City of Fenton  
 Old Highway 141 Bridge Value Engineering Proposal  
 Final VE Quantities  
 3/29/2011

**OLD HIGHWAY 141  
ROADWAY IMPROVEMENT PLANS**  
FENTON, MISSOURI  
Prepared For:  
**CITY OF FENTON**

**Re: Value Engineering of Fenton Creek Bridge Replacement  
Project No. BRM-4989(606), Bridge No. 1420013  
Response to Review Comments and Revised Final Plans**

DETAILS OF END BENT NO. 1  
SHEET 3 OF 5

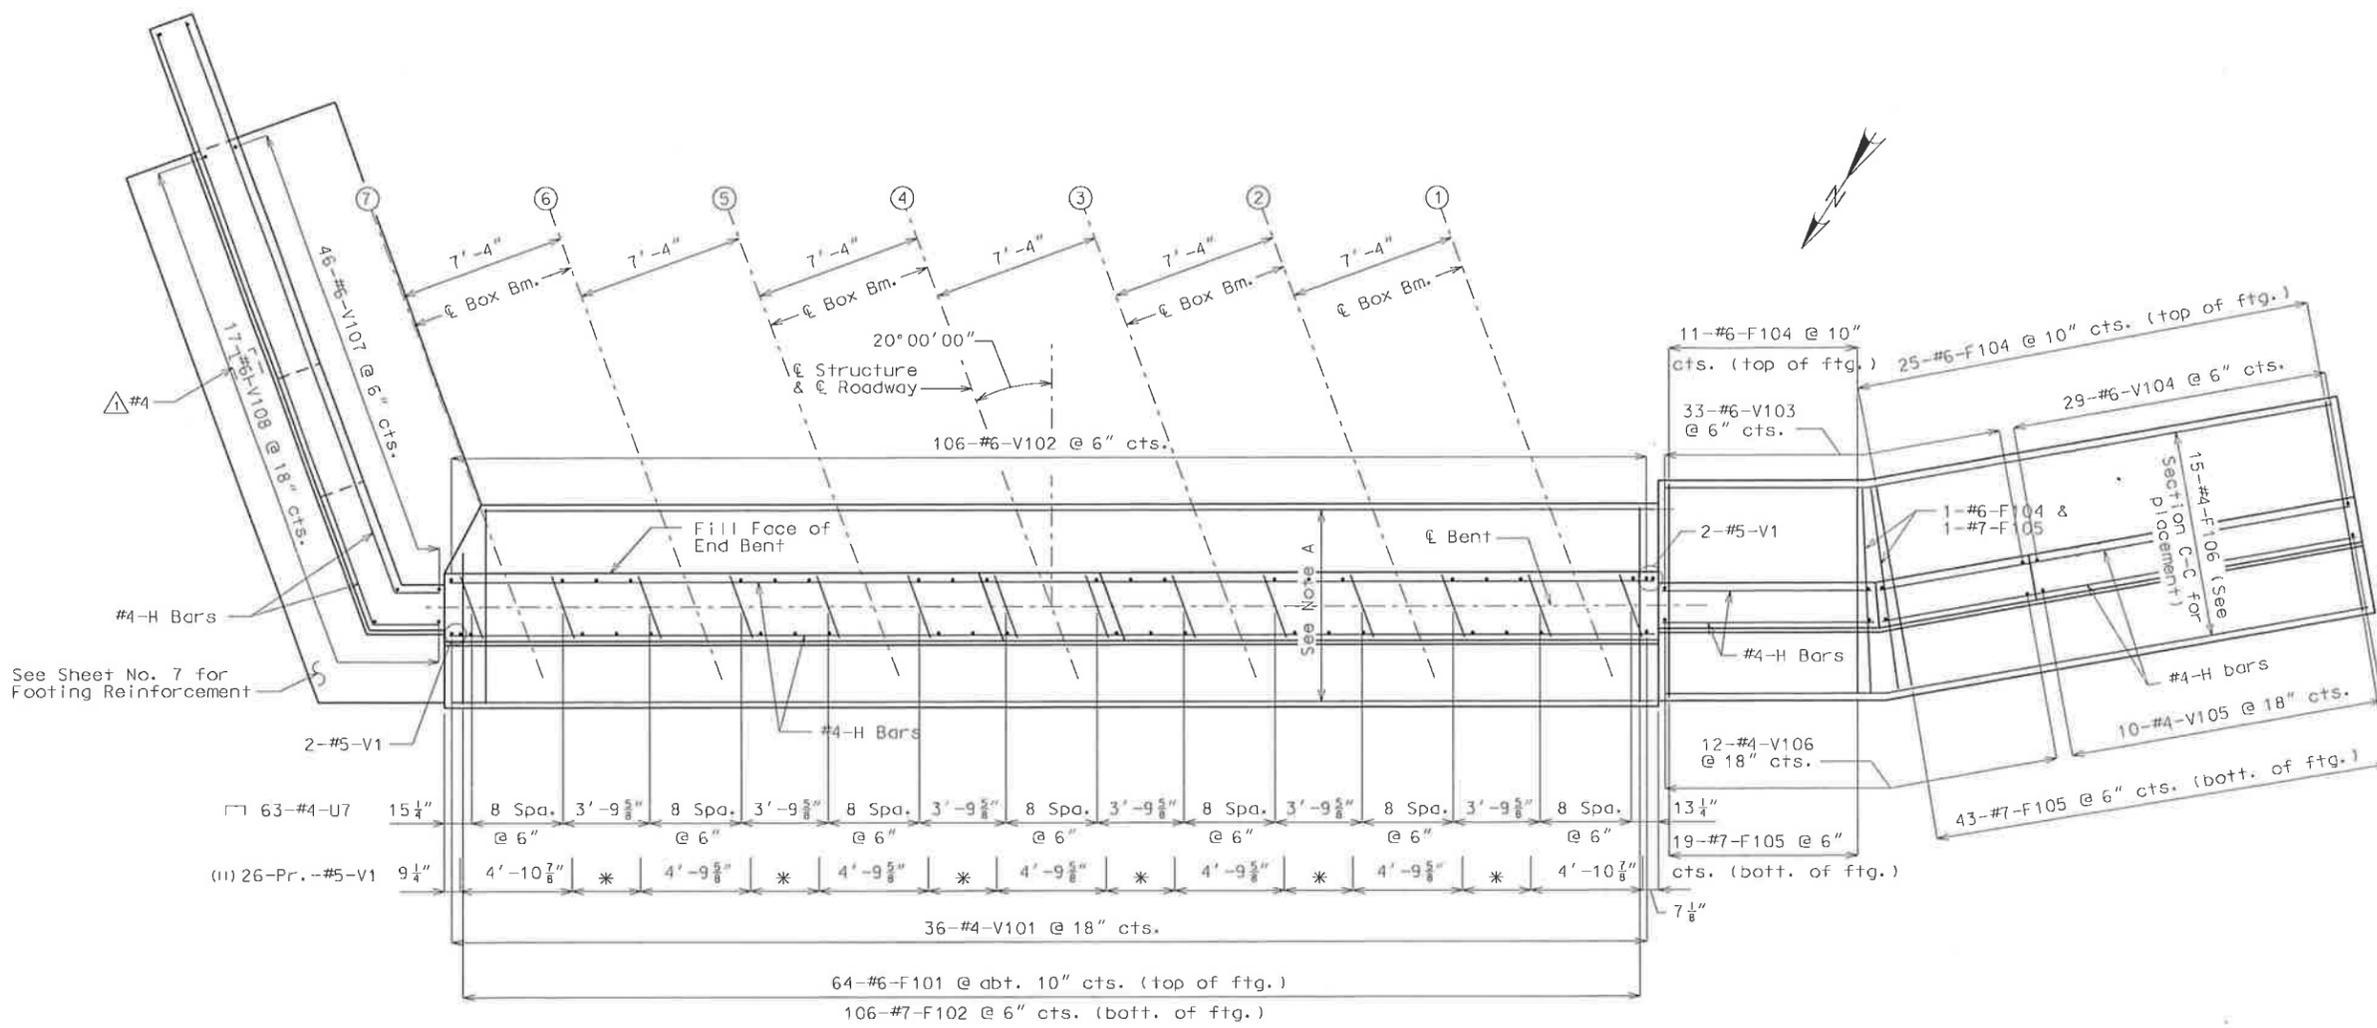
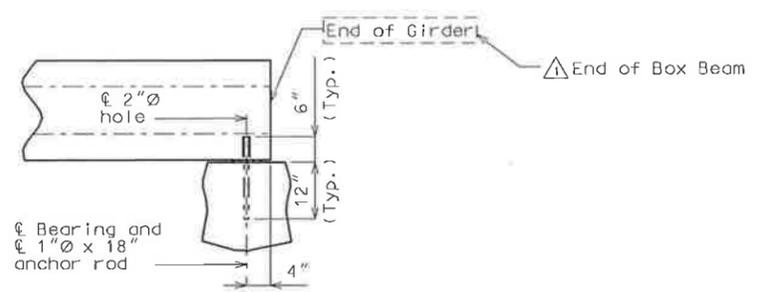
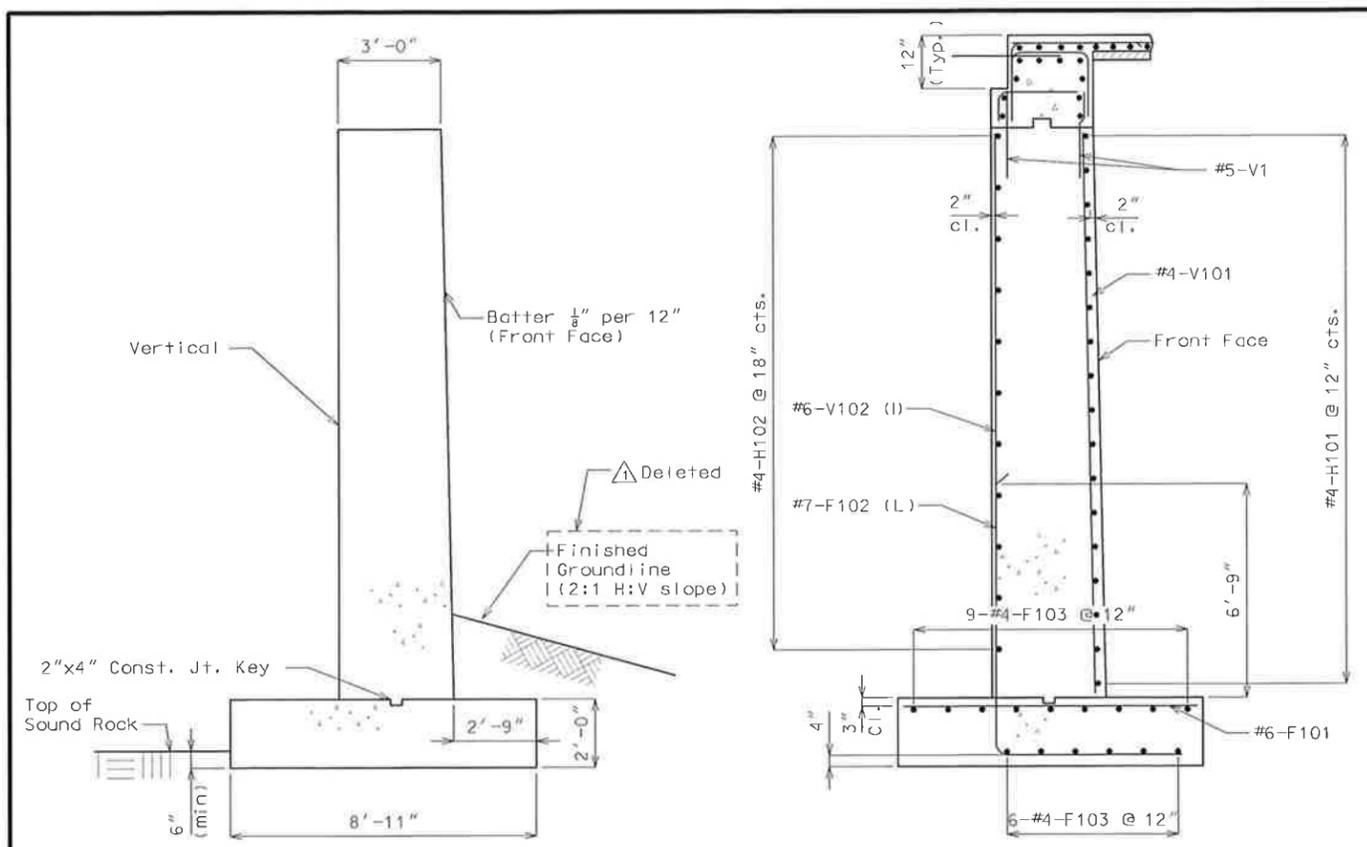
20. Callout in PLAN OF BEAM SHOWING REINFORCEMENT on right side indicates *15-#4-F106 bars* (See Section C-C for placement). Section C-C on Sheet No. 6 indicates *10-#4-F106 @ 12"*. Which is correct? Correct BILL OF REINFORCING STEEL on Sheet No. 16 if required. **15 bars is correct – there are 10 top bars and 5 bottom bars as shown in the section.**
21. Should V108 bars called out on left side of PLAN OF BEAM SHOWING REINFORCEMENT be #4 bars instead of #6 bars as shown for other front face reinforcement (#4-V105 & #4-V106)? If so, revise callout and correct BILL OF REINFORCING STEEL on Sheet No. 16. **V108 bars should be #4, Sh. 2, 5, 7 and 16 have been revised accordingly.**
22. Revise callout to read *End of Box Beam* instead of *End of Girder* in ANCHOR ROD DETAIL. **Plans revised accordingly.**

### DETAILS OF END BENT NO. 1

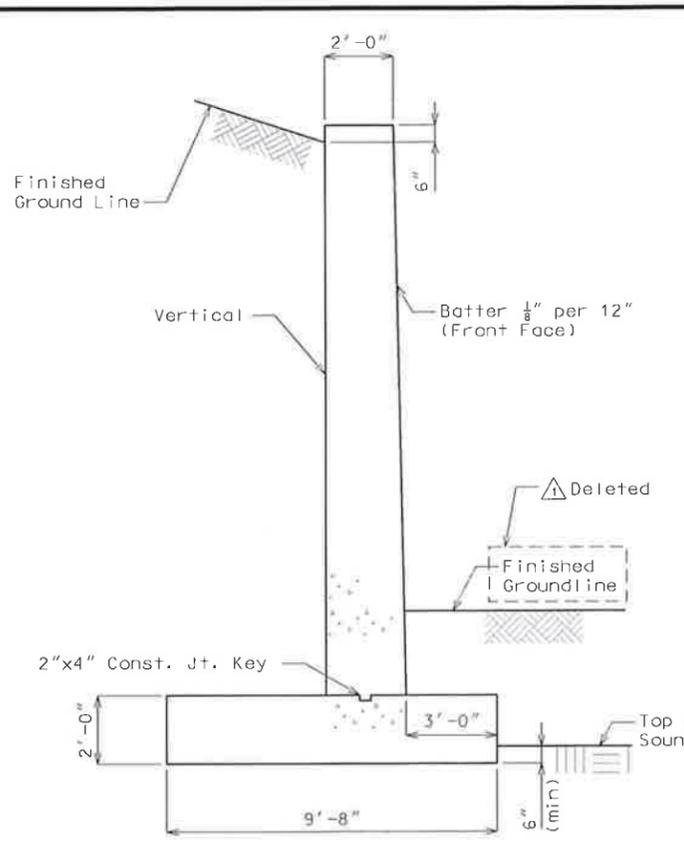
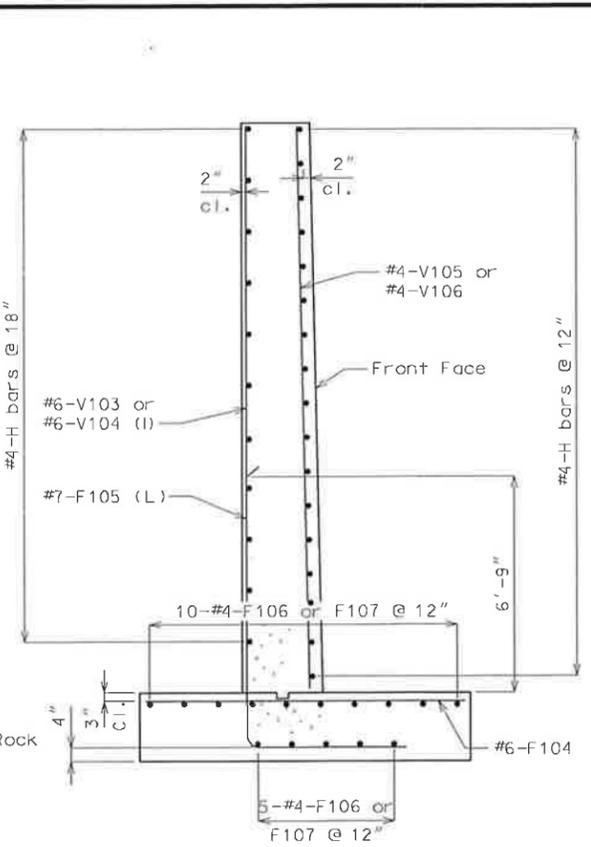
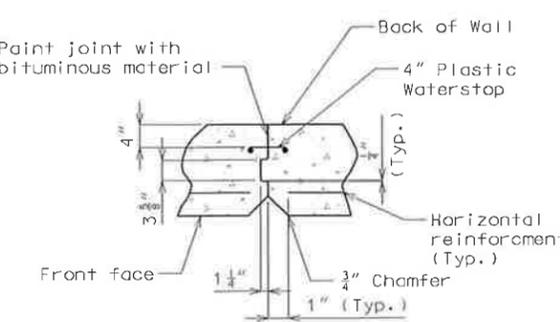
23. See comments for #4-F106 & F107 bars noted under Sheet No. 5. **See response to note. 20.**
24. See comments for #4-F111 & F112 bars noted under Sheet No. 7. **See response to note. 28.**
25. Revise callouts on Sections A-A & C-C to refer to *Riprap* instead of *Finished Ground Line* or remove callouts. **Callouts removed.**
26. Add additional dimensions for footings to clarify intent in Sections A-A & C-C. **I assume you are referring to the dimensions of the bottom of stem and heel. These dimensions were intentionally not shown because they vary based on wall height due to battered stream face of stem. The wall height varies due to varying sound rock elevations. See note under Developed Section on Sh. 3.**

27. Add elevation callout at bottom of footings for Section A-A & C-C. **The elevations were intentionally left off because bottom of footing is tied to sound rock elevations which vary. For quantity purposes, a sound rock elevation of 397.00 was assumed as shown on Sh. 3. The elevations were not shown in sections to help reinforce that rock elevations vary.**

OLD HIGHWAY 141  
BRIDGE OVER  
FENTON CREEK  
DETAILS OF END BENT NO. 1  
SHEET 5 OF 5

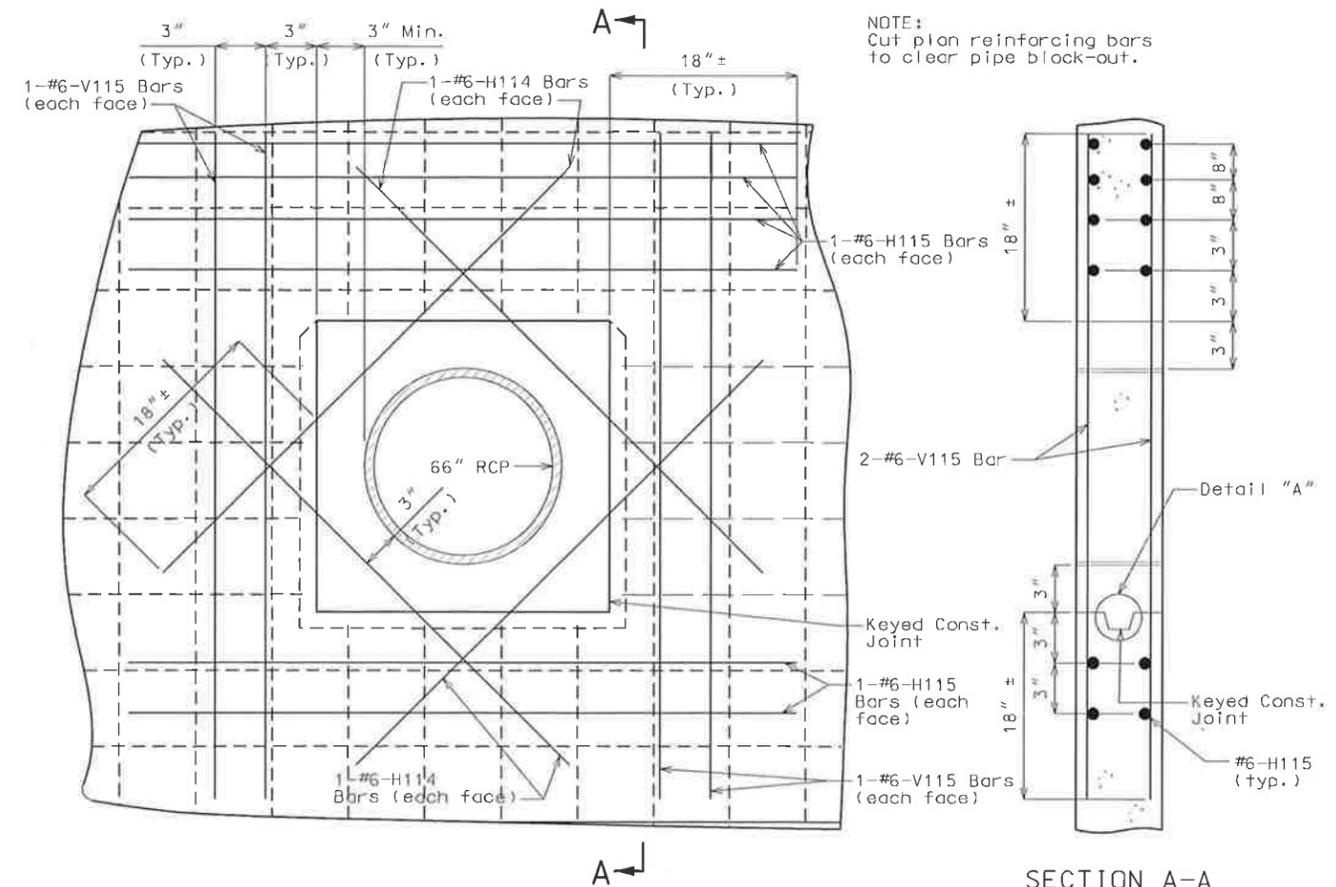
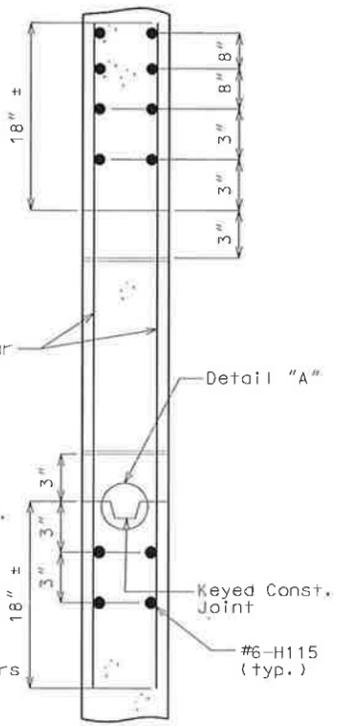
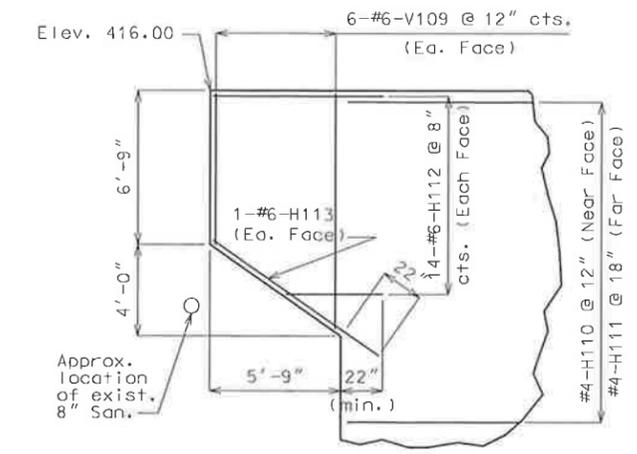
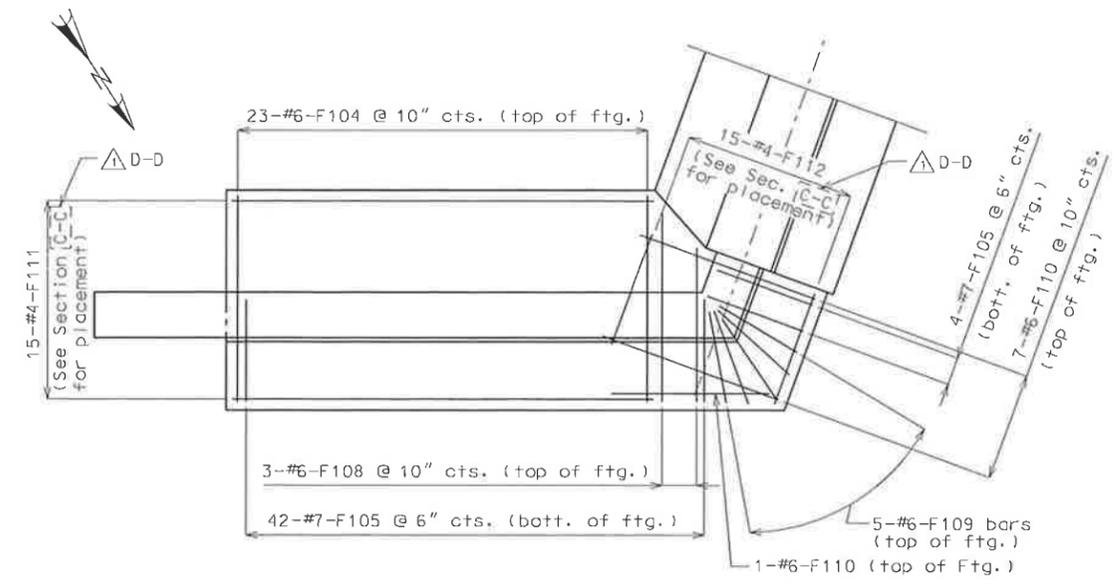
28. FOOTING PLAN OF NORTH WING SHOWING REINFORCEMENT calls out 15-#4-F111 & 15-#4-F112 (See Section C-C for placement). These callouts should refer to Section D-D (which is noted as being similar to Section C-C) on Sheet No. 6. Section C-C on Sheet No. 6 indicates 10-#4-F106 or F107 @ 12". This would seem to indicate that there would also be 10-#4 F111 or F112 bars. Is this correct? Correct BILL OF REINFORCING STEEL on Sheet No. 16 if required. **Callout revised to Section D-D; 15 bars is correct – see response to note 20.**

29. Clarify size of block-out for 66" Pipe (no size is explicitly provided). Is intent to have min. of 3" from pipe for approx. 72" square opening? **Your interpretation is correct – no clarification warranted. Verify that additional reinforcement provided around block-out is adequate? . The additional reinforcement is adequate and exceeds that required by MoDOT Standard Plan 703.60.**

NOTE: DRAWINGS ARE NOT TO SCALE. FOLLOW DIMENSIONS  
OLD HIGHWAY 141  
BRIDGE OVER  
FENTON CREEK  
DETAILS OF END BENT 2  
SHEET 1 of 3

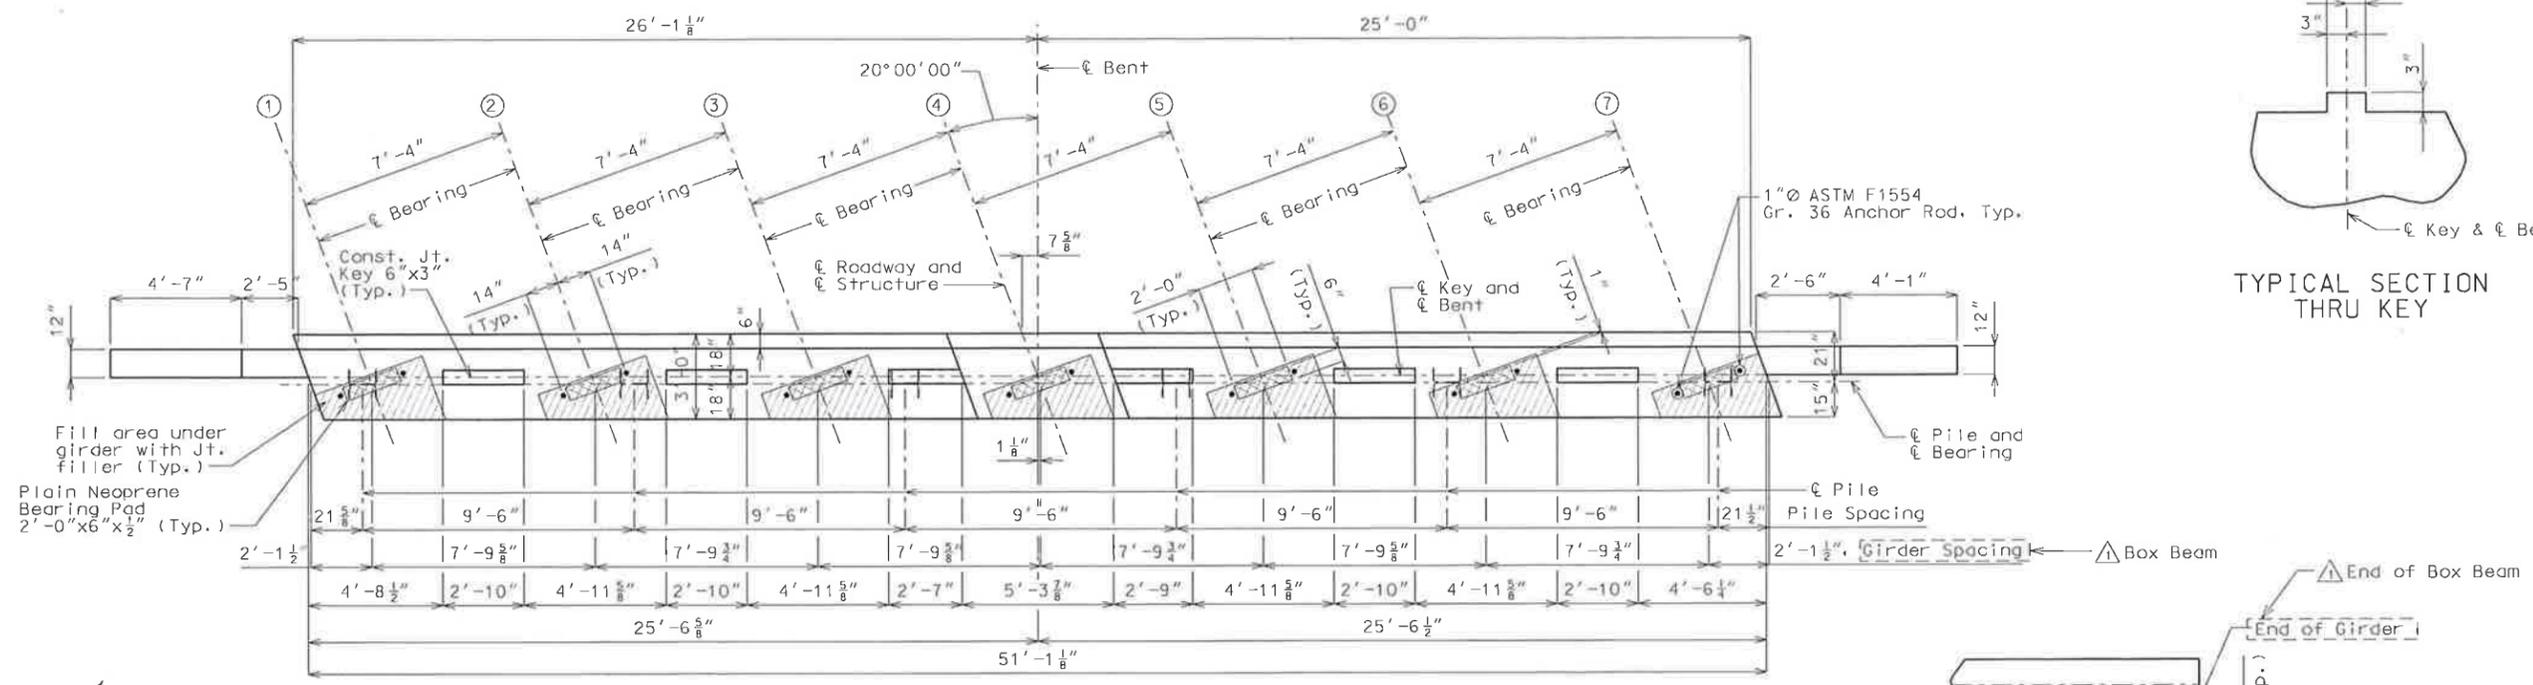
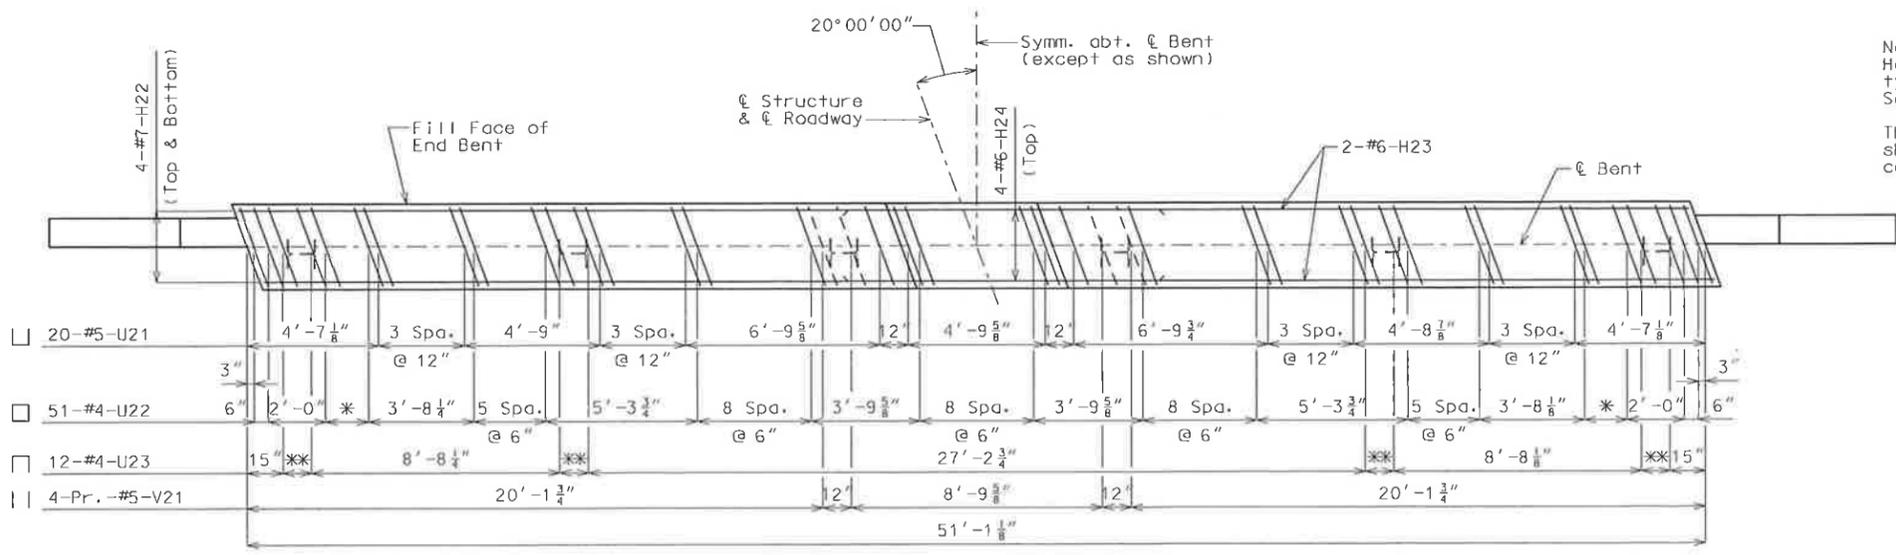
31. Revise callout to read *Box Beam Spacing* instead of *Girder Spacing* in PLAN OF BEAM SHOWING DIMENSIONS. **Plans revised accordingly.**
32. Revise callout to read *End of Box Beam* instead of *End of Girder* in ANCHOR ROD DETAIL. **Plans revised accordingly.**
33. Remove or revise note below PLAN OF BEAM SHOWING REINFORCEMENT stating "*Cut or bend U1 and V1 bars to fit*". These bars are not in End Bent No. 2. **Plans revised accordingly.**
